Project Name:	Suburban Propane	Project ID:	2016-047
Address:	636 Riverside Street	CBL:	322-A-3
Applicant:	Thompson's Point Development Co.	Planner:	Nell Donaldson

Suburban Propane, 636 Riverside Street
Level III Subdivision and Site Plan Review
2016-047
Suburban Propane

Submitted to: Portland Planning Board Date: June 23, 2016 Public Hearing Date: June 28, 2016	Prepared by: Nell Donaldson, Planner CBLs: 322-A-3 Project #: 2016-047
--	--

Figure 5: Preliminary site plan

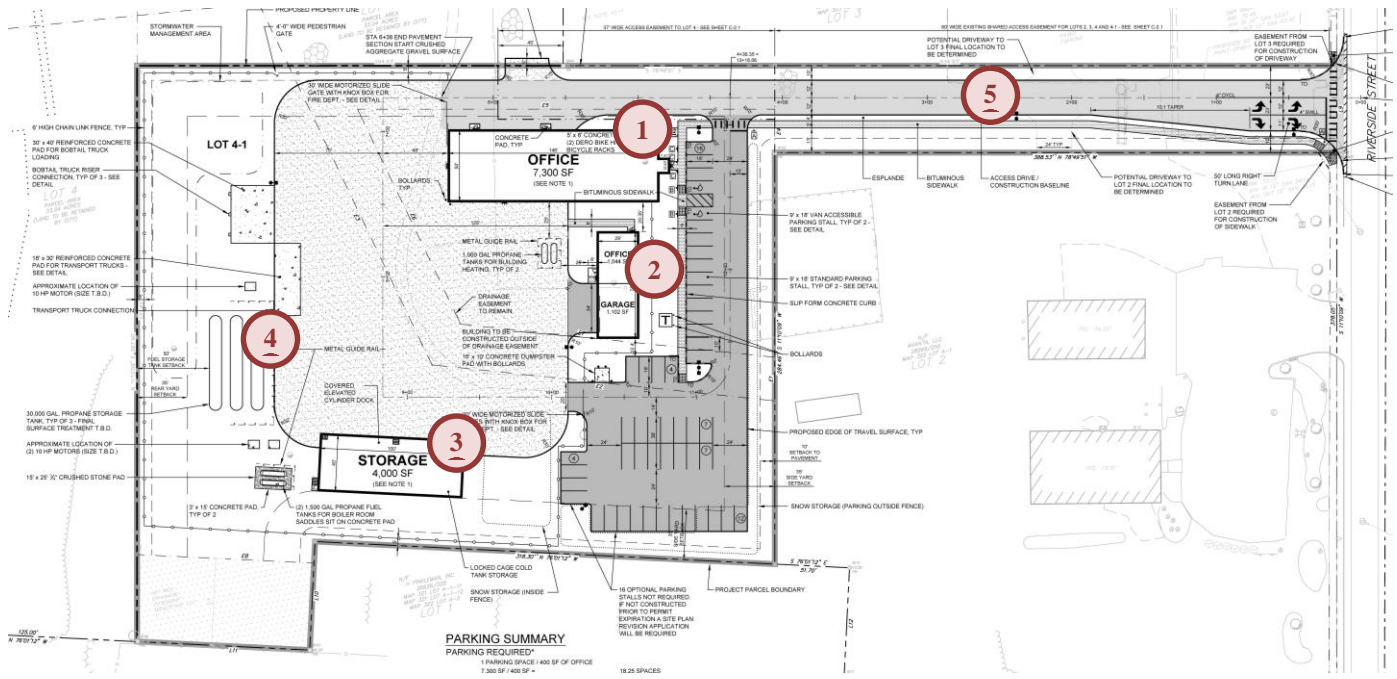
Division 20 of the land use ordinance establishes a parking requirement of 1/400 SF for office spaces and 1/1,000 SF for industrial buildings not catering to retail trade and with floor area over 3,000 SF. Based on these ratios, 24 parking spaces are required. The applicant’s final plans show 50 spaces in a paved parking lot to serve the 30-34 existing full time employees and 14 additional employees that might be housed at the site in the future. The applicant has noted in their final submittal that they may elect not to build these spaces. Mr. Errico has requested additional clarity on this point, writing,

The plans should either illustrate parking spaces intended for construction or they shall be removed them from the plans.

A condition of approval has been drafted to address the parking as shown in the site plan.

Figure 6: Sidewalk and Driveway Plan, Riverside Subdivision Plat

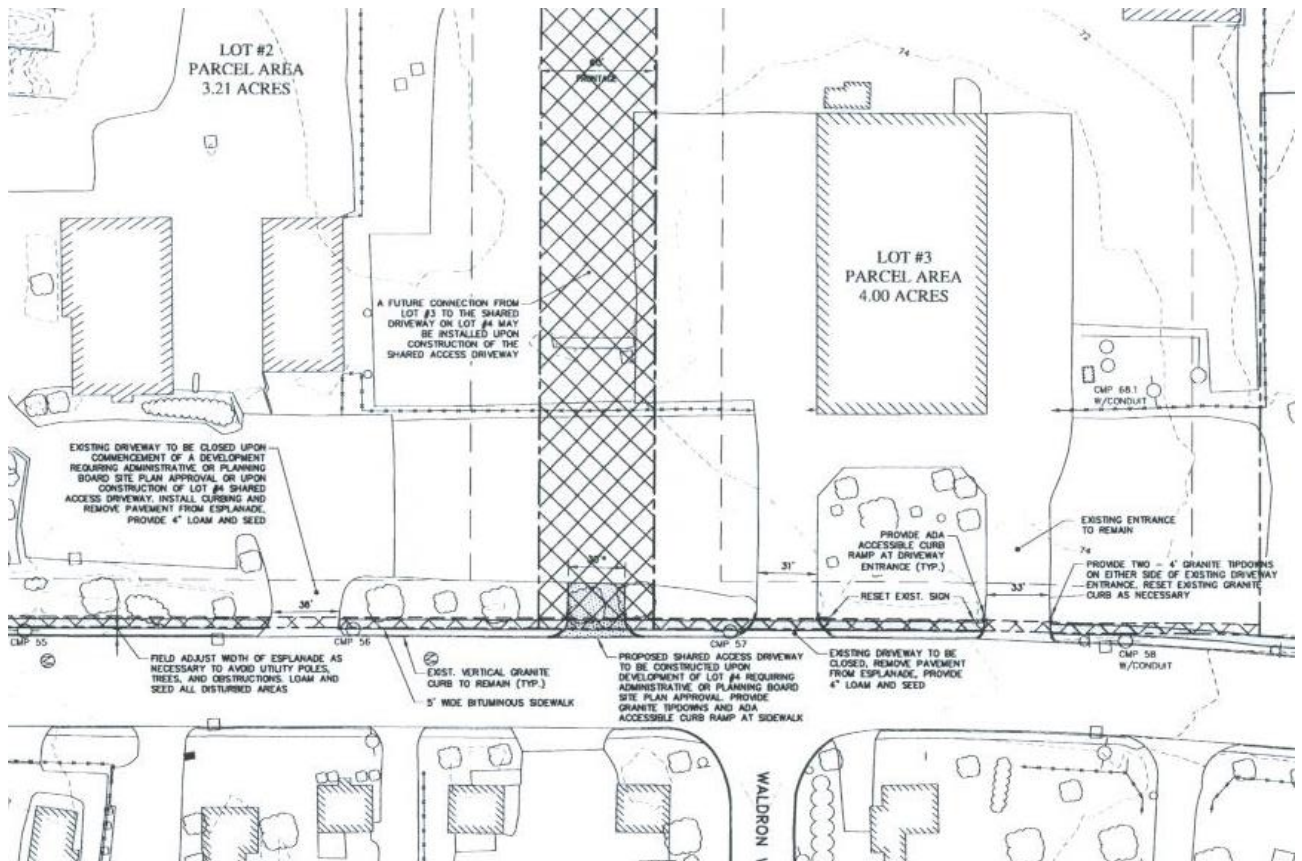
The plans include a new 24' access drive from Riverside Street. The final plans show two "potential" points of access from this drive to the adjacent lots (Lot 2 and Lot 3). These access points are a product of the original Riverside Subdivision plat. Pursuant to the development of this subdivision plat, the City of Portland granted a shared access driveway easement to Lot 2 (Ananta LLC) and Lot 3 (Addison Capital LLC "for the purpose of and conveying the right to perpetually enter at any and all times" over the access to Lot 4 from Riverside Street (*Attachment D*). Subsequently, the parties developed a Shared Access Driveway Maintenance Agreement, which stipulates that, when Lot 4 is developed, the owner of Lot 4 is to be responsible for constructing the shared access driveway, that the owner Lot 3 is entitled to access their lot via the driveway by providing written notice to the owners of Lots 2 and 4, and lastly, that the owners of Lot 4 will share maintenance of the shared driveway "with Lot 2 and/or Lot 3 in a reasonable proportionate share reflecting the length of the shared access driveway used by each lot and the approximate number of trips made by vehicles to and from each lot" (*Attachment D*). The applicant has acknowledged that the final location of these access points will be resolved pending future discussions with the adjacent property owners. Mr. Errico writes,

The plan notes approximate driveway locations for Lots 2 and 3. I find the currently depicted locations to be acceptable. Any changes to the locations shall be reviewed and approved by the City.

A condition of approval has been drafted to address this likelihood.

SHEET TITLE: **SITE LAYOUT PLAN**

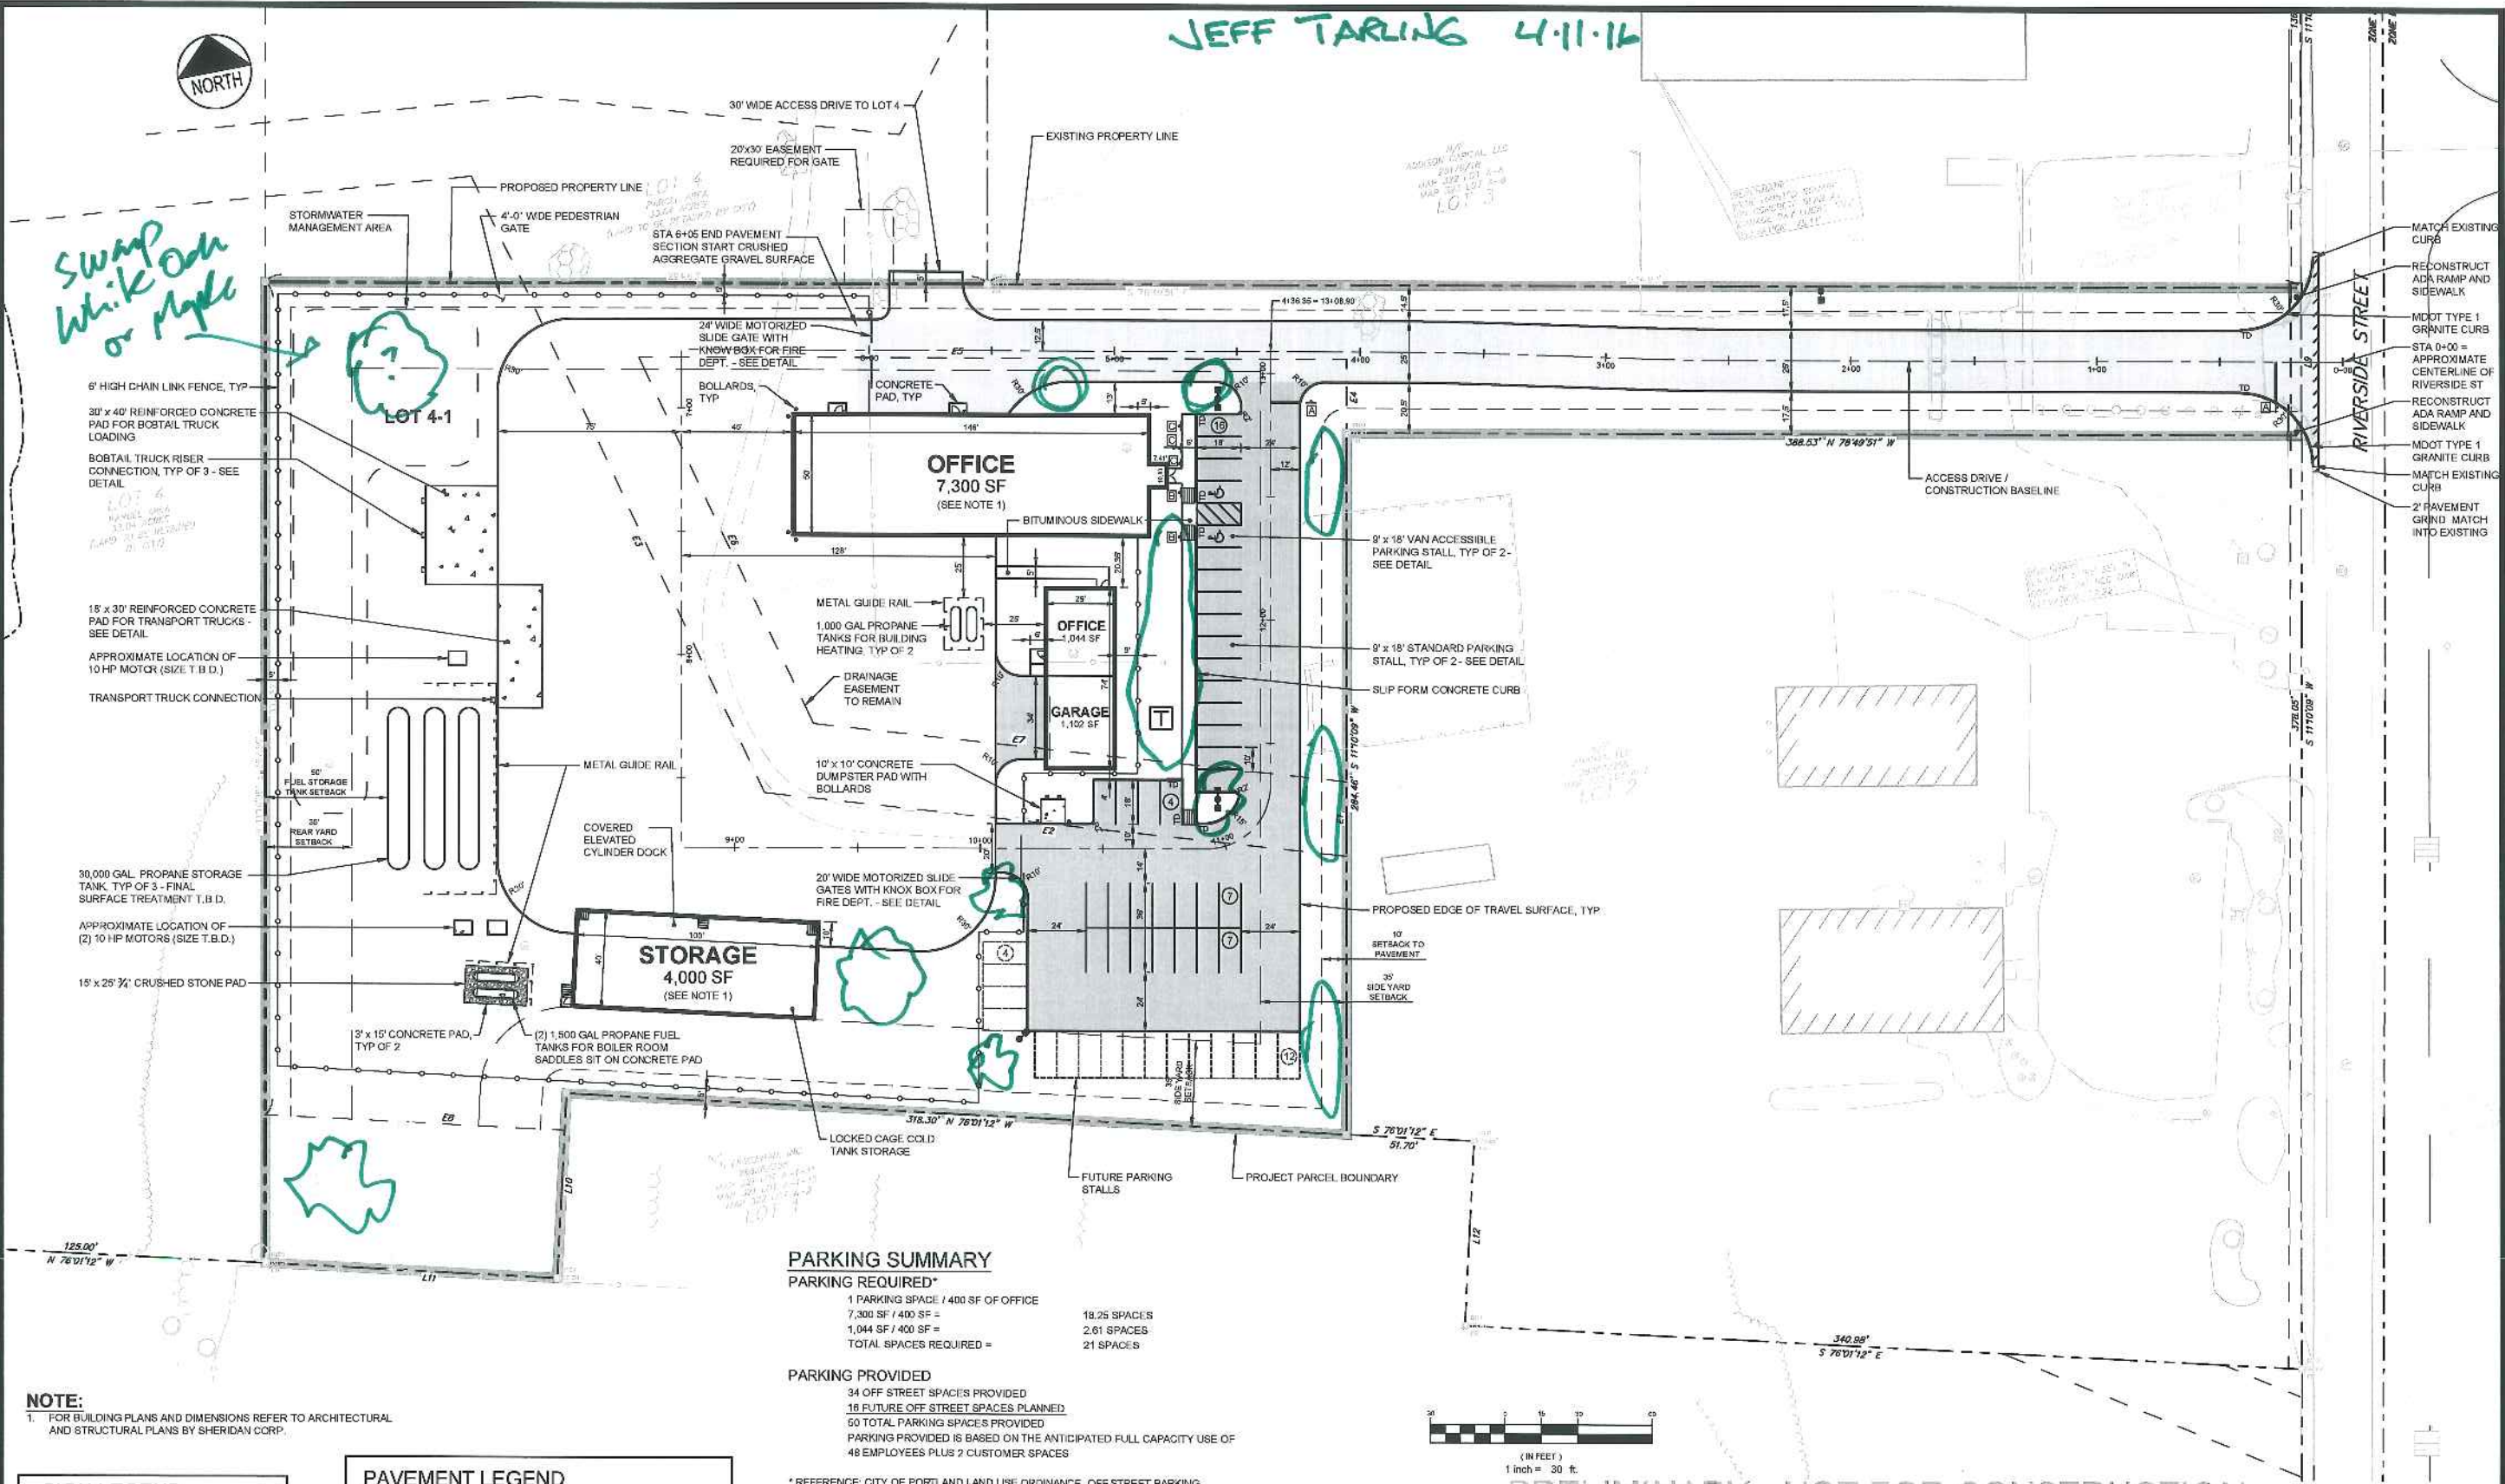
The proposed 636 Riverside Street project would benefit from a landscape / tree planting plan. The landscape plan should address any new parking areas, commercial property to city right of way interface, this would be the view to the site and landscape treatment to improve circulation. The landscape improvements could be incremental to the proposed site work vs the entire site.
